20-DDP-0047

Revised Detailed District Development Plan BAE Systems Expansion

Planning & Zoning Committee
January 12, 2021

Landscape Detail

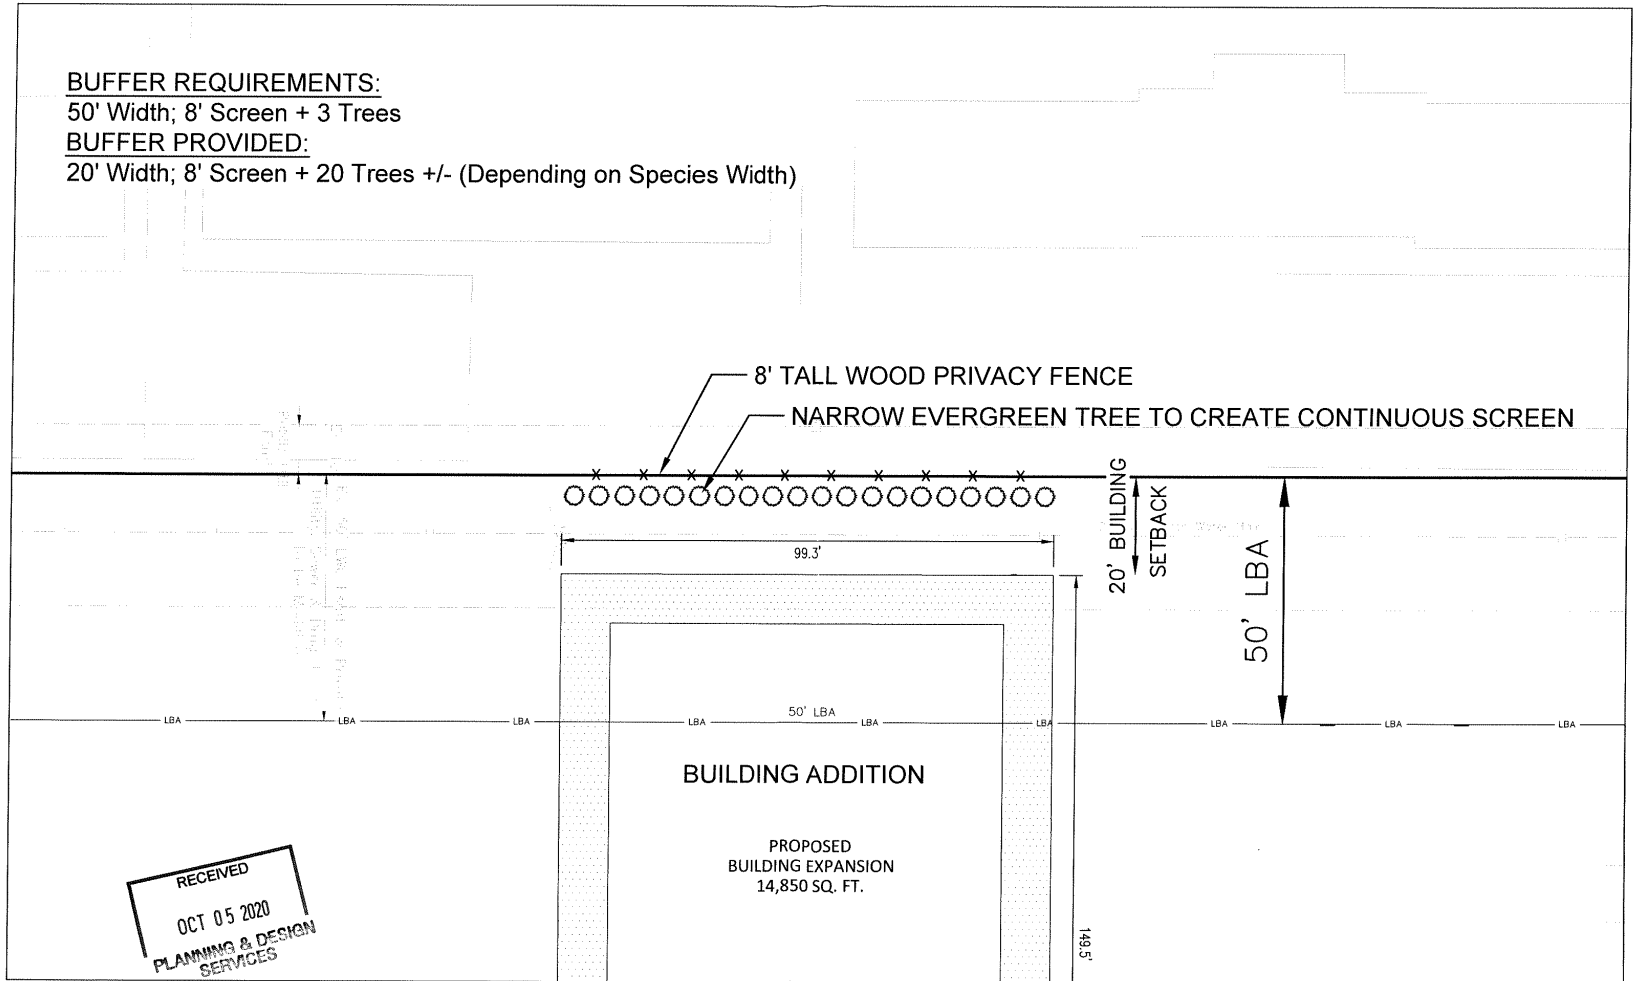
BUFFER REQUIREMENTS:

50' Width; 8' Screen + 3 Trees

BUFFER PROVIDED:

20' Width; 8' Screen + 20 Trees +/- (Depending on Species Width)

BAE EXPANSION LANDSCAPE AND SCREENING EXHIBIT

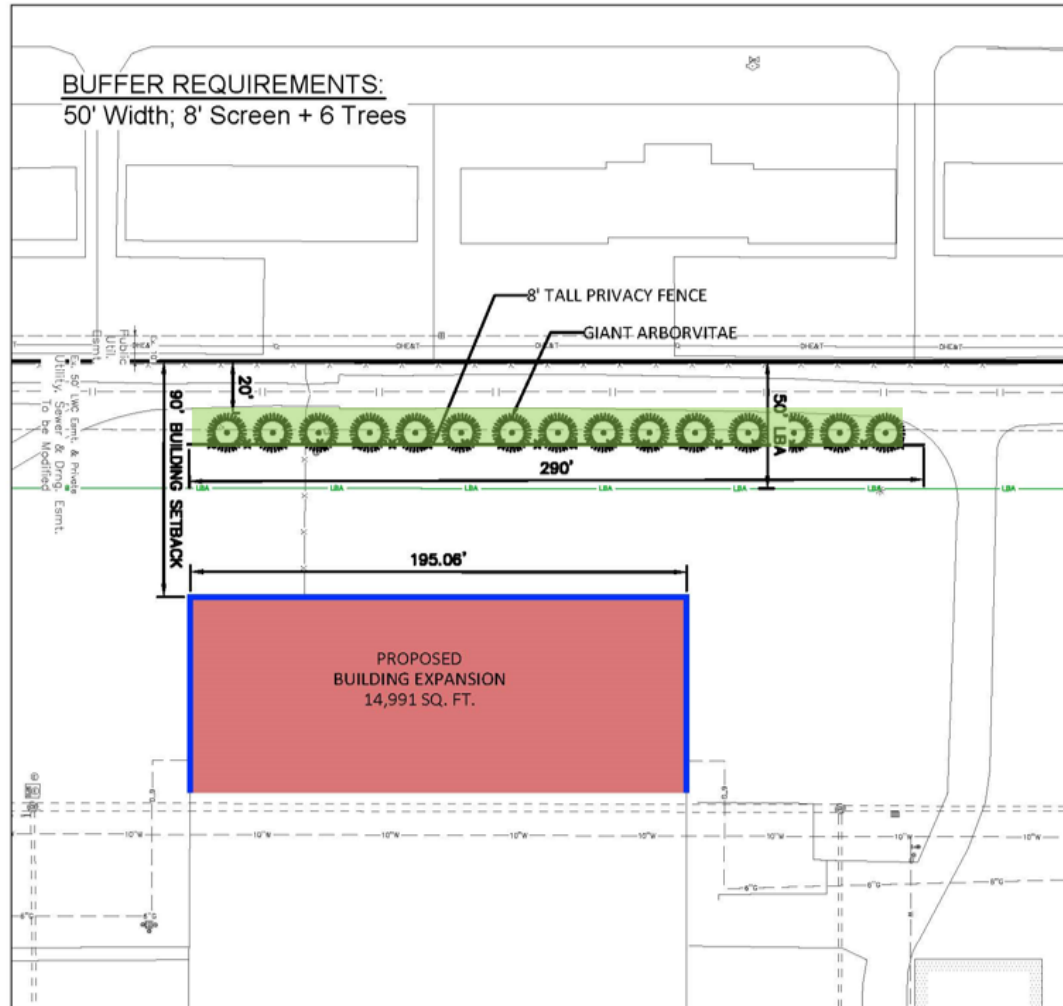
8. The applicant shall provide screening as shown on the landscaping exhibit present to the Development Review Committee on October 14, 2020, with the plantings and screening extending from the western edge of Building A to the eastern side of building B at the drive lane. The final location and type of trees shall be shown on the approved landscape plan and chosen in conference with Planning and Design Services staff landscape architect.

8. The applicant shall provide screening as shown on the landscaping exhibit present to **Metro Council on January 12, 2021**, with the plantings and screening extending from the western edge of Building A to the **western** side of building B at the drive lane. The final location and type of trees shall be shown on the approved landscape plan and chosen in conference with Planning and Design Services staff landscape architect.
